PUBLIC MEETING TOWN OF HUDSON, NH December 9, 2015

> D. Orchard at Nottingham (OSD) Subdivision SB# 09-15

E. Hudson Hilltop Self-Storage Expansion SP# 11 – 15

Staff Report December 9, 2015

Webster Street Rezoning Amendment

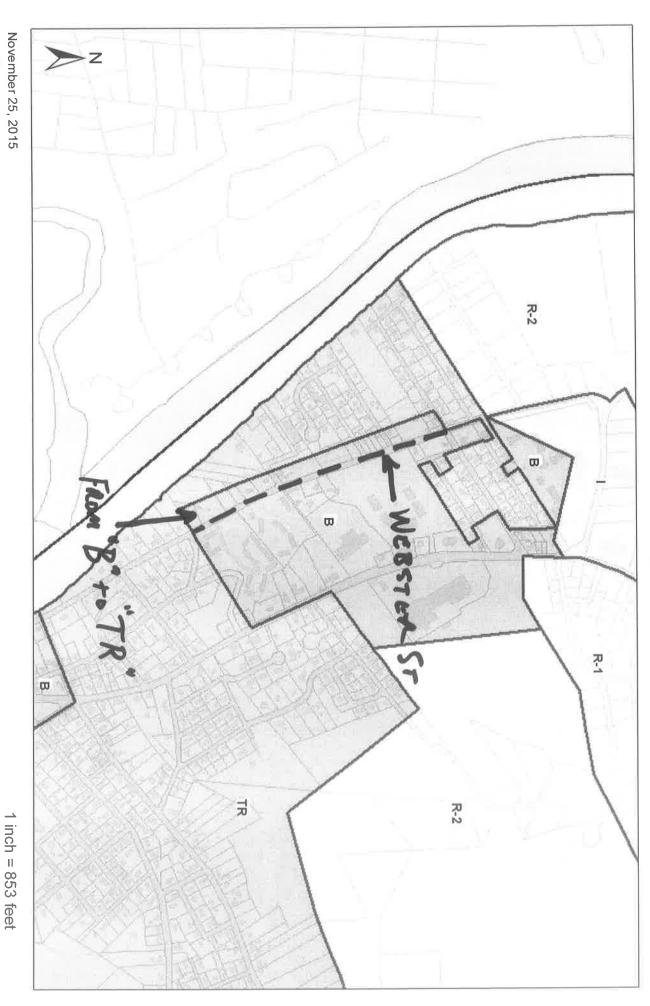
RECOMMENDATION: The above hearing notice reflects Planning Board action at the 28 OCT and 18 NOV meetings, relative to rezoning the above-cited parcels. In preparation for the hearing, and after receiving a legal opinion from NH Municipal Association's Counsel, Atty. Steve Buckley, because fewer than 100 property owners will be affected by this proposed zoning amendment, all property (condominium) owners were notified of this hearing by first-class mail. Atty. Buckley's legal opinion is attached as "A" on the 1 Elmwood Drive Rezoning Amendment staff report. Attached hereto, is a Map showing the proposed amendment entitled: "Webster Street Rezoning Amendment".

11-30-15 HEV. 2 | 11/24/2014 | DIE JU/) NOTE PLAN "Orchard at Nottingham

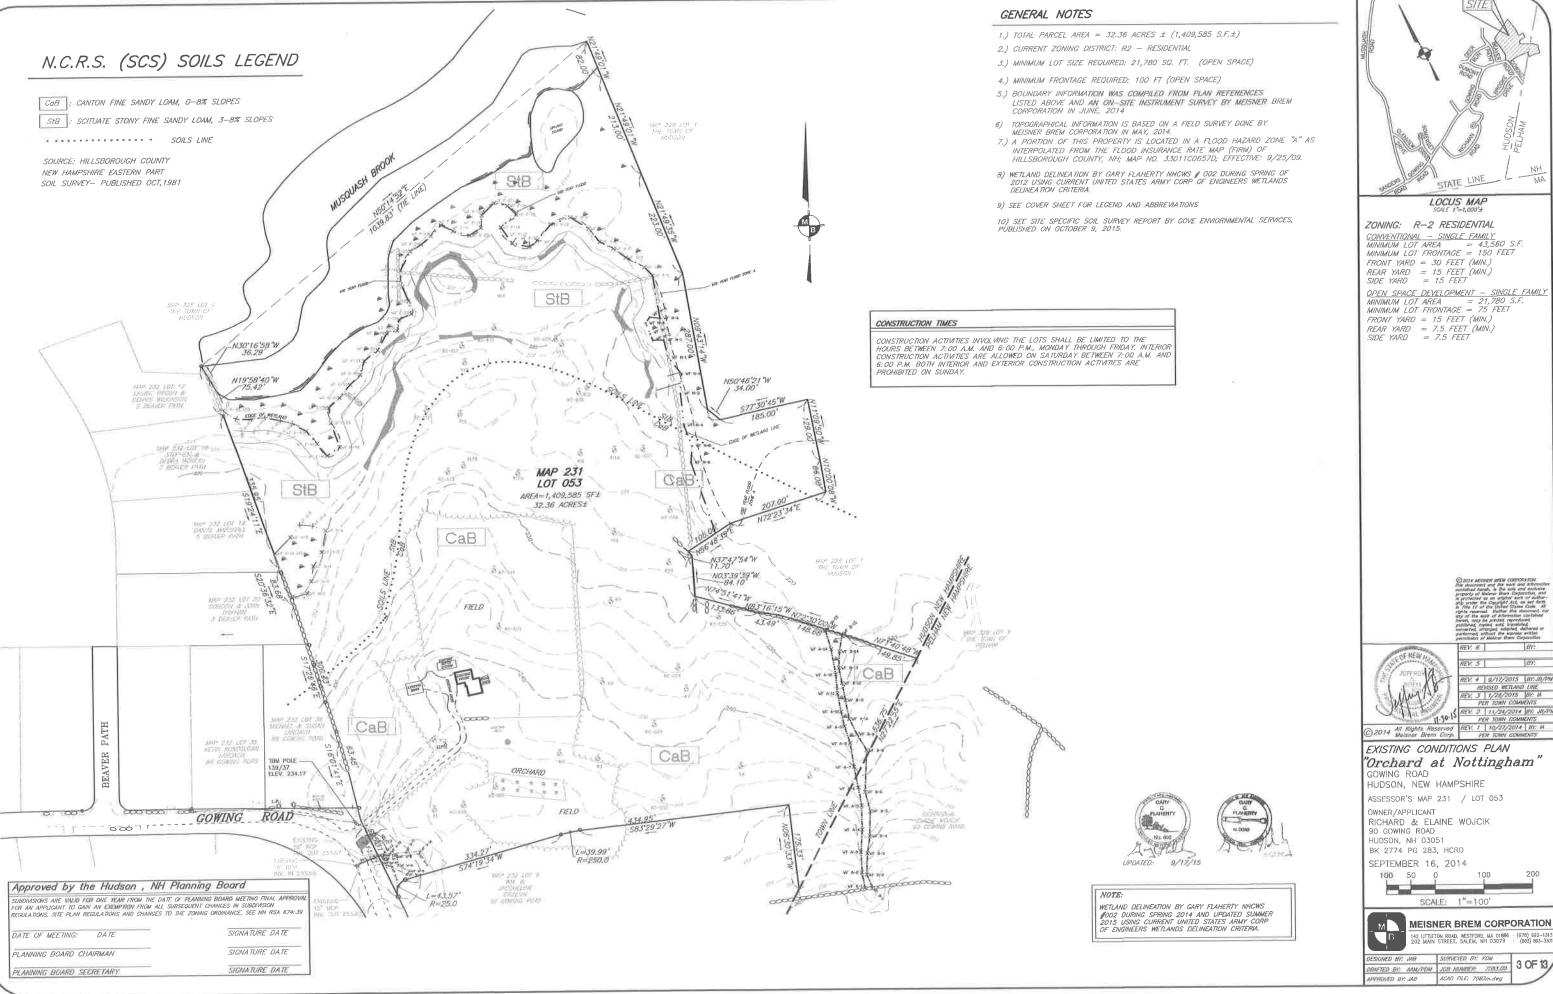
- 7. The Plan notes need to be amended to include a note citing that the retention pond located on Lot 10 shall be privately maintained ad infinitum.

c. Former CLD Comments: The plans show individual wells, but a new note added to sheet 2 of 13 discusses a community well system. The applicant should clarify the intent. / The applicant removed the note regarding the community well system from the plans. No further CLD comment.

- 12) Prior to Planning Board endorsement of the Plan, a Note shall be added to it, citing that the retention pond located on Lot 10 shall be privately maintained ad infinitum.

4 OF 13,

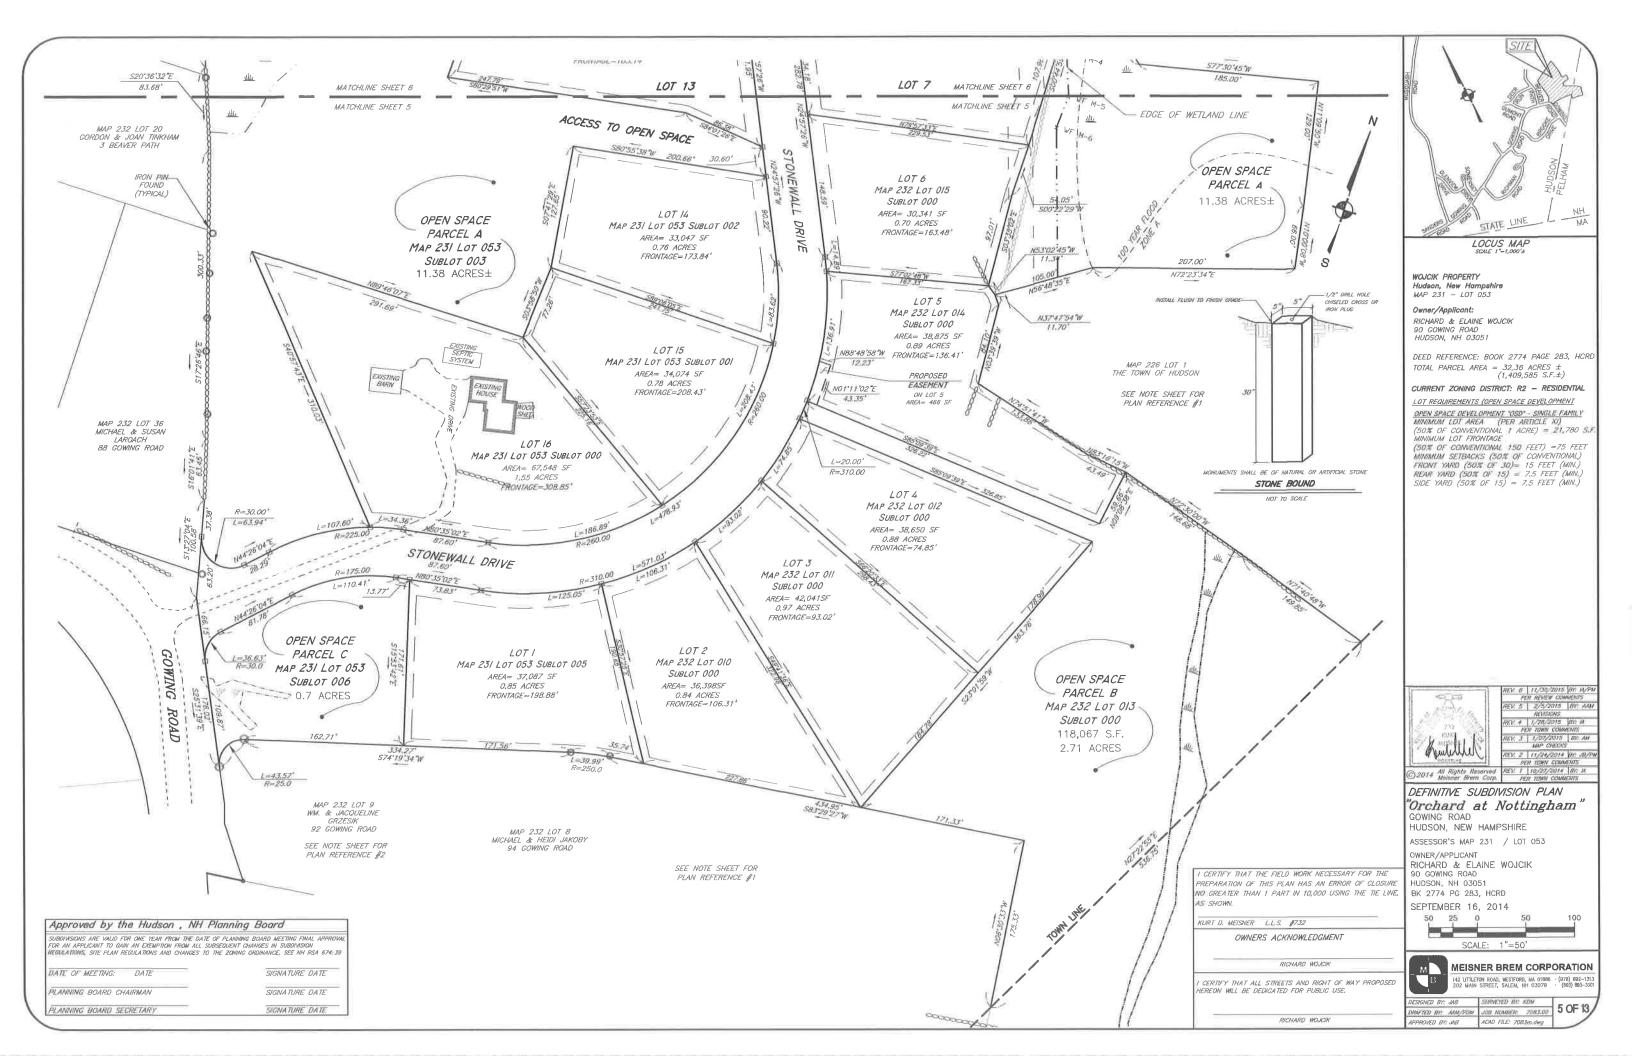
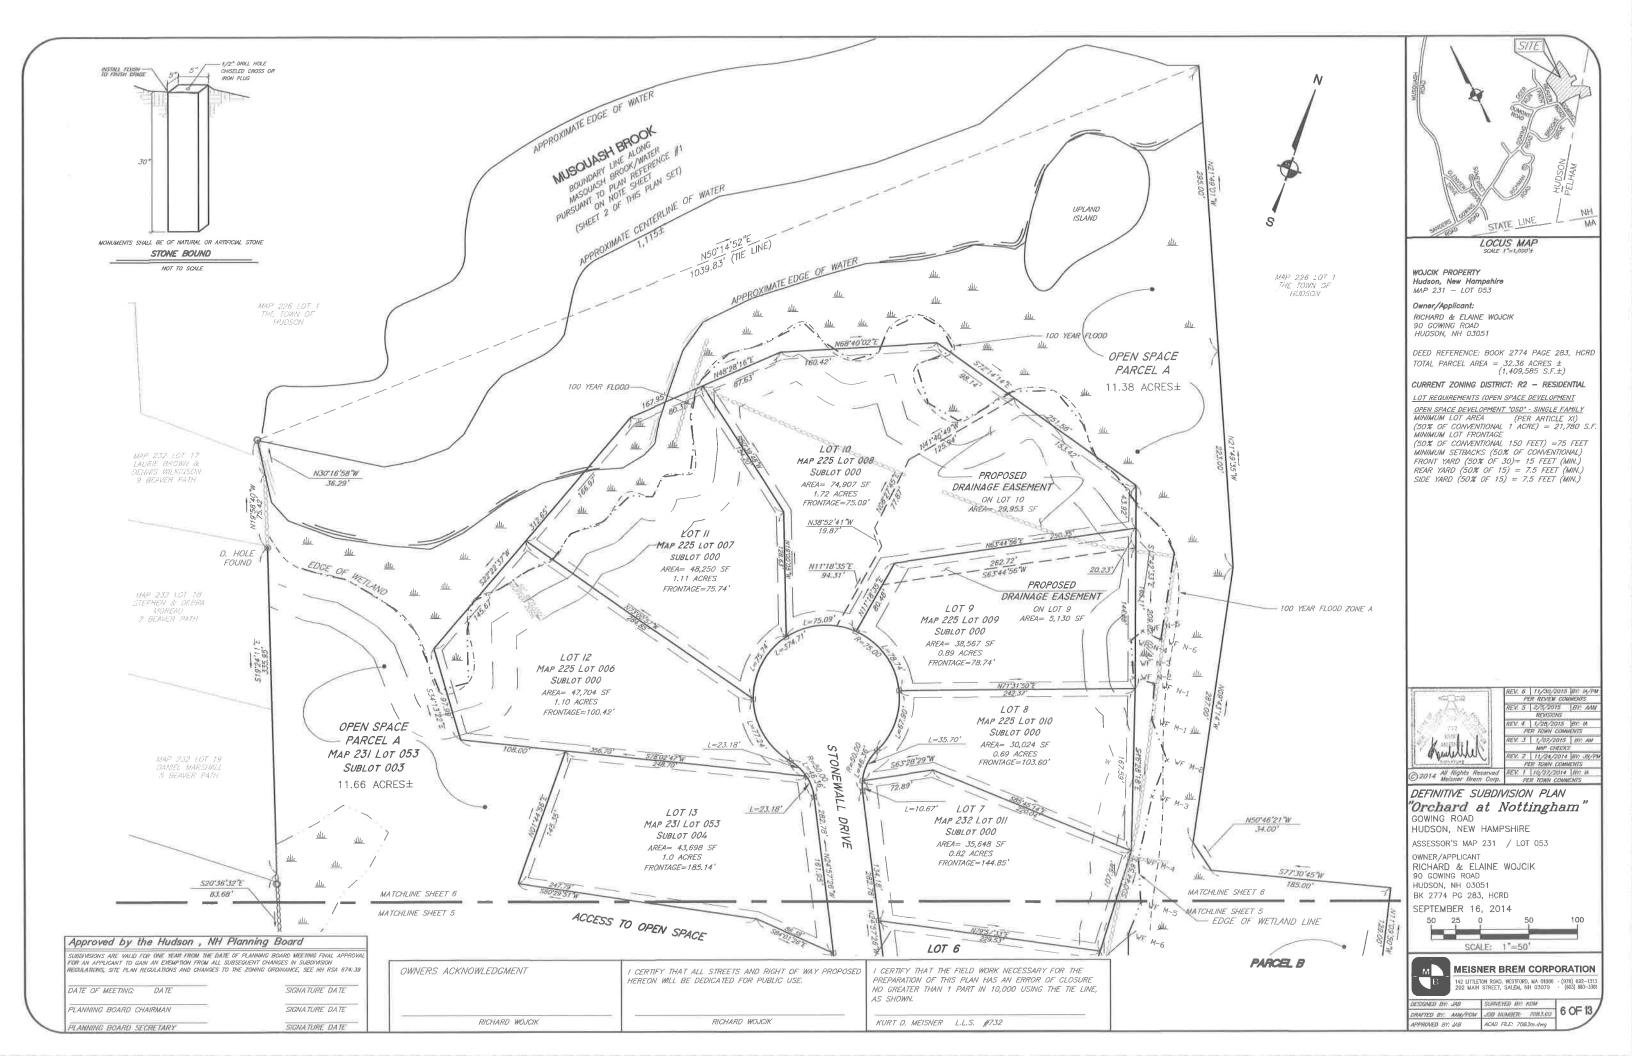
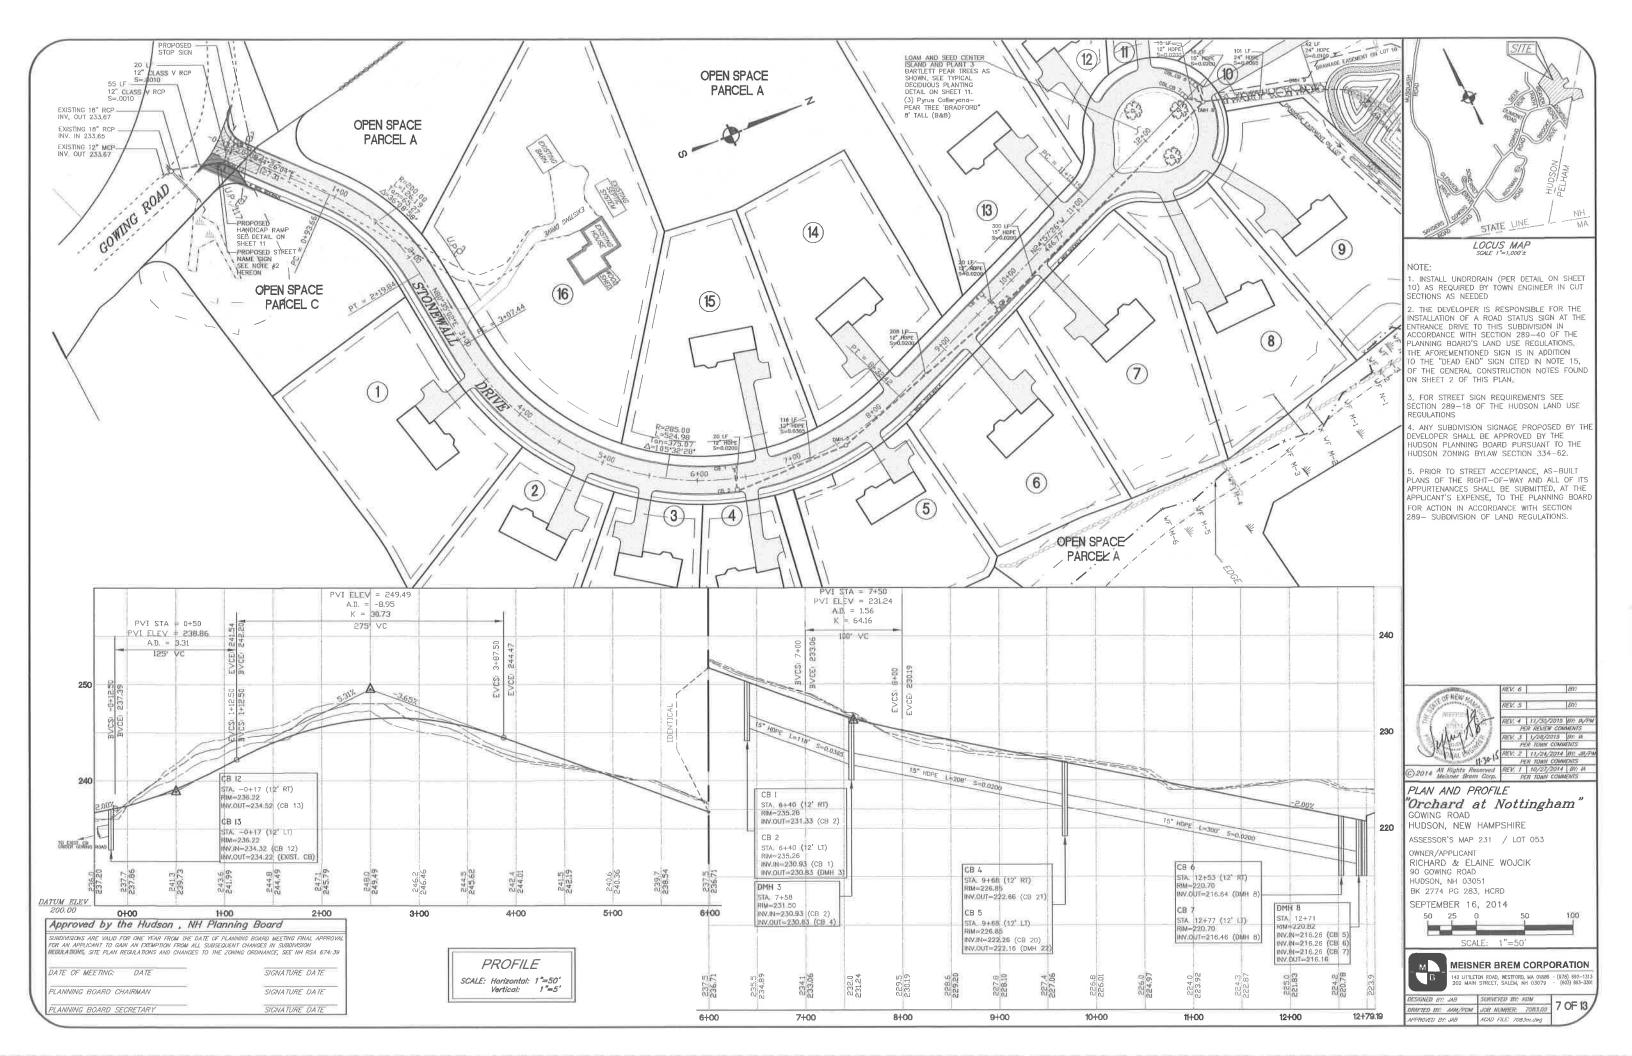
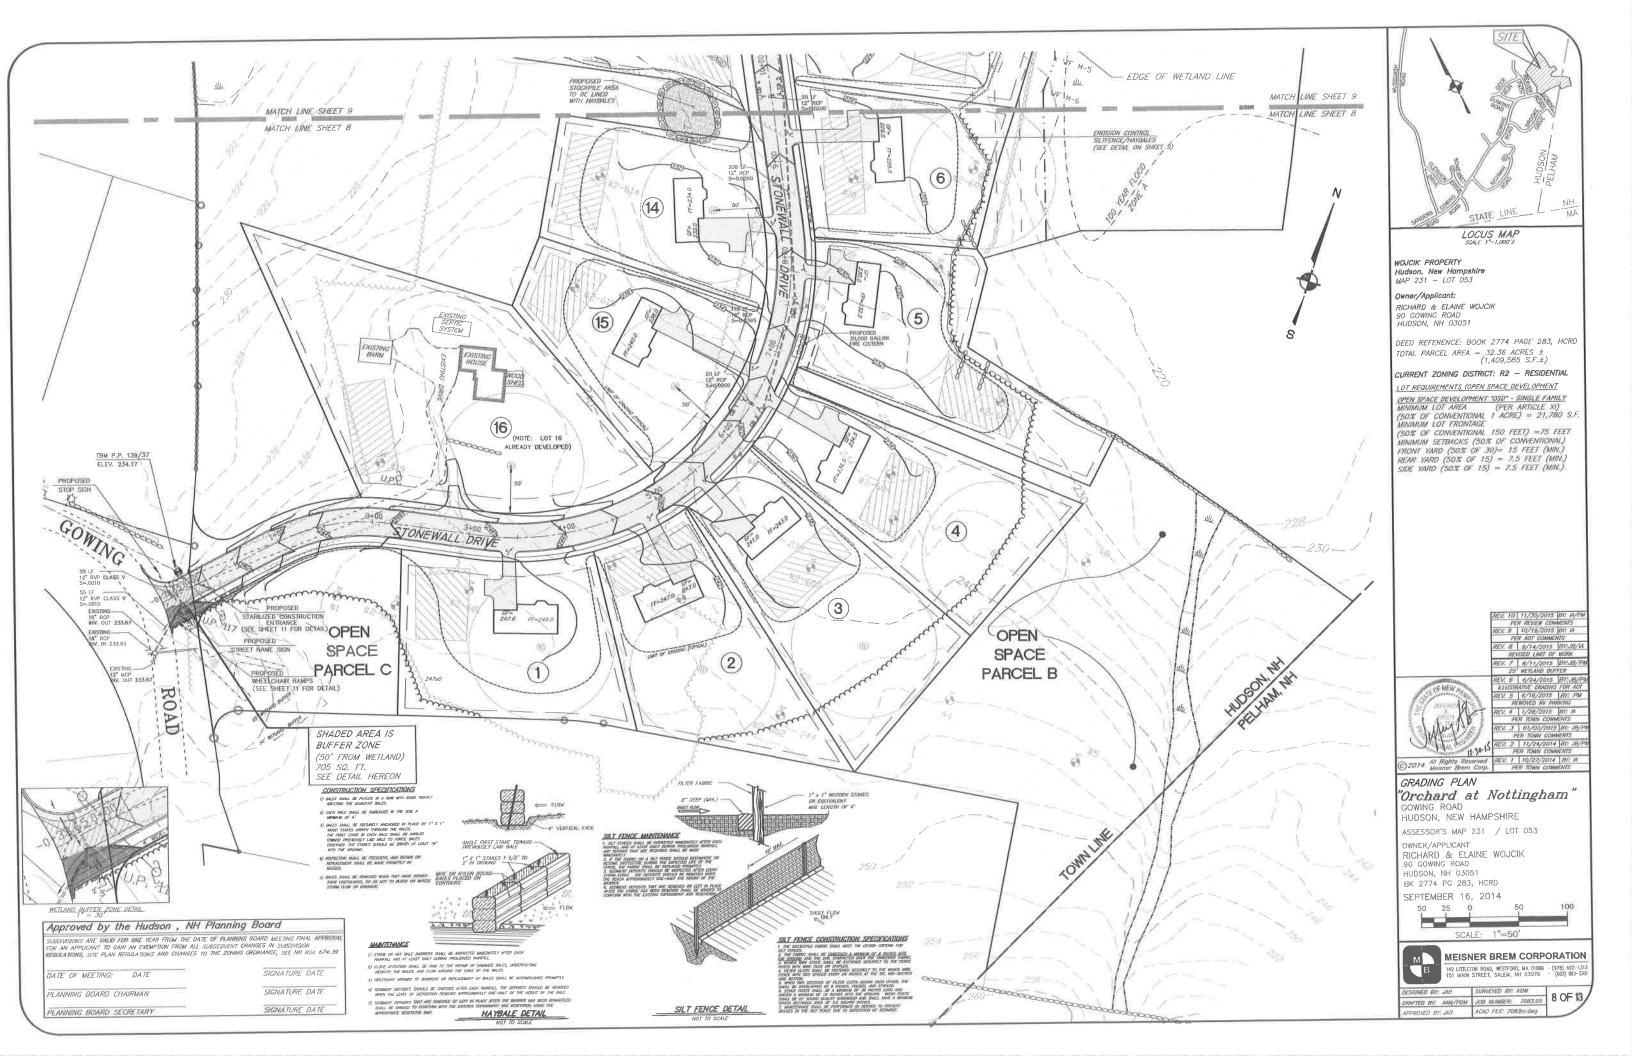
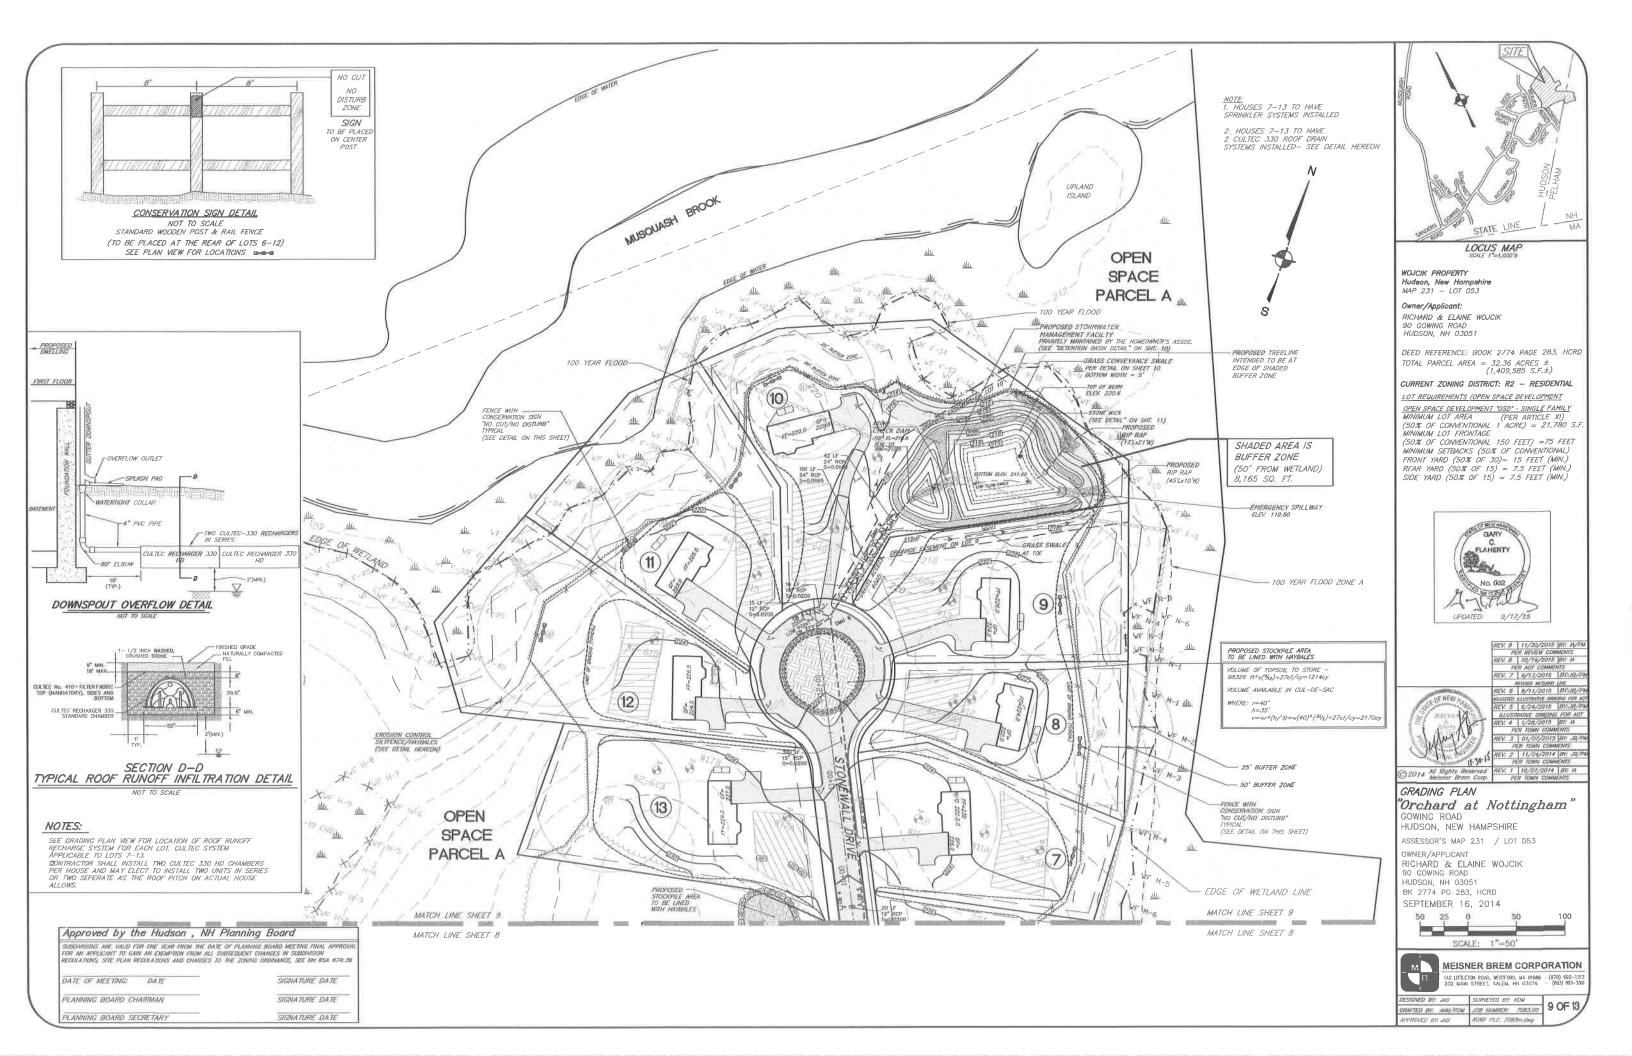
- 6) Construction activities involving the lots shall be limited to the hours between 7:00 A.M. and 6:00 P.M., Monday through Friday. Interior construction activities are allowed on Saturday between 7:00 A.M. and 6:00 P.M. Both interior and exterior construction activities are prohibited on Sunday. Note: this condition shall be properly inscribed on Sheets 3 and 4 of the Plans prior to Planning Board endorsement of same.
